Work Order ID 86840

Item Name: Crosstube Fwd

DART AEROSPACE LTD	Work Order: 86840
Description: Crosstube High Fwd (205/212/412)	Part Number: D212-664-101
Inspection Dwg: D212-664-141 Rev: D	Page 1 of 1

DRAWING NO. D212-664-141	TITLE XTUBE ASSY (205/212/412 HI FWD)	REV. D	DART AEROSPACE LTD ENGINEERING ORDER		D.E.O. NO. D212-664-141-D-1	SHEET NO. SHEET 1 OF 2	SCALE NTS
DRAWN	CHECKED <i>OP</i>	MFG. APPR. <i>ER</i>	APPROVED <i>MAP</i>	DE APPR. <i>MAP</i>			
DATE 11.04.07	DATE 11.04.11	DATE 11.04.12	DATE 11/04/12	DATE 11.04.12

**D212-664-141/-141B
ASSEMBLY DETAIL**

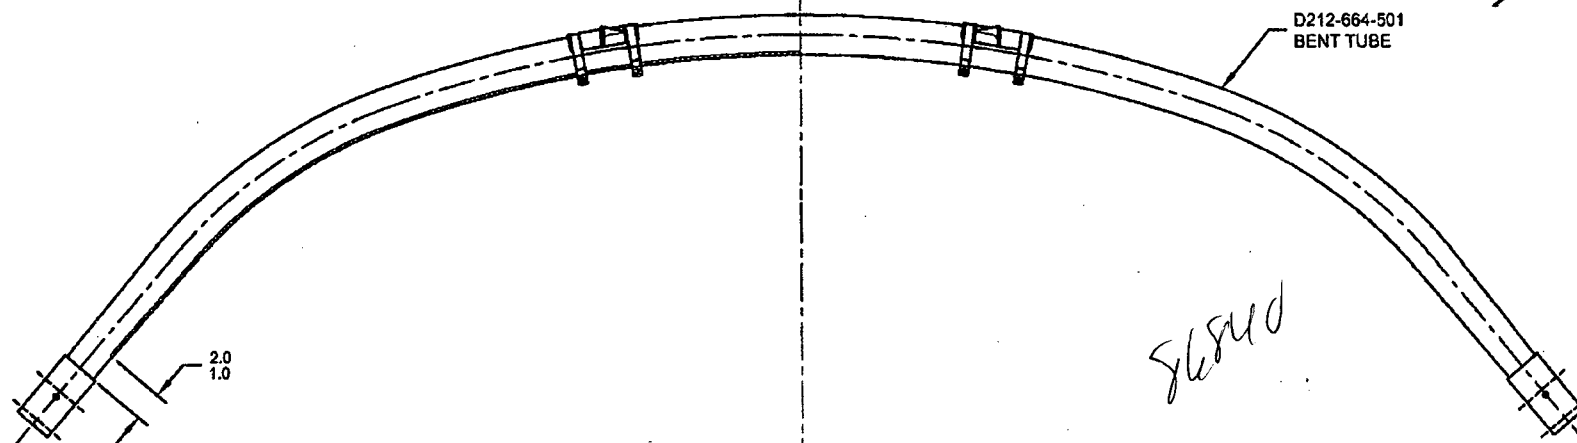
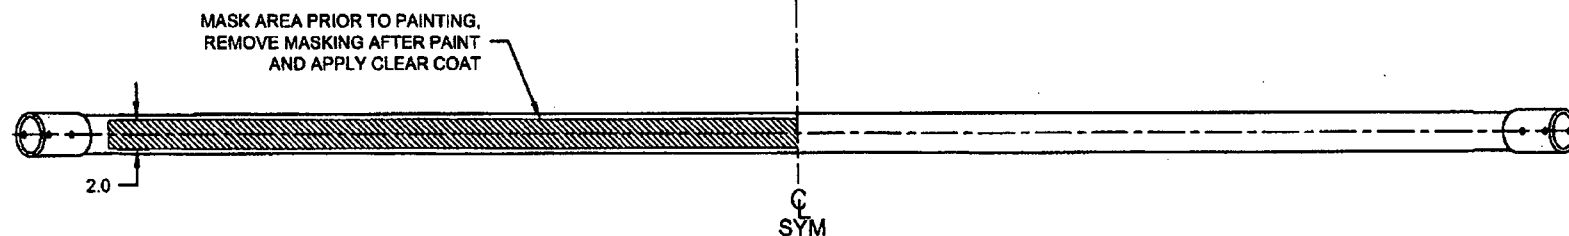
PURPOSE:

ADD AN INSPECTION WINDOW TO UNDERSIDE OF CROSSTUBE.

NOTES 2 OF SHEET 1 IS AMENDED AS FOLLOWS:

IS:

- 2) FINISH: CHEMICAL CONVERSION COAT PER DART QSI 005 4.1
PRIME INSIDE AND OUTSIDE PER DART QSI 005 4.2
MASK UNDERSIDE OF CROSSTUBE AS SHOWN (HATCHED AREA) AND
PAINT OUTSIDE PER DART QSI 005 4.2
REMOVE MASKING AND APPLY CLEAR COAT

WAS:

- 2) FINISH: CHEMICAL CONVERSION COAT PER DART QSI 005 4.1
PRIME INSIDE AND OUTSIDE PER DART QSI 005 4.2
PAINT OUTSIDE PER DART QSI 005 4.2
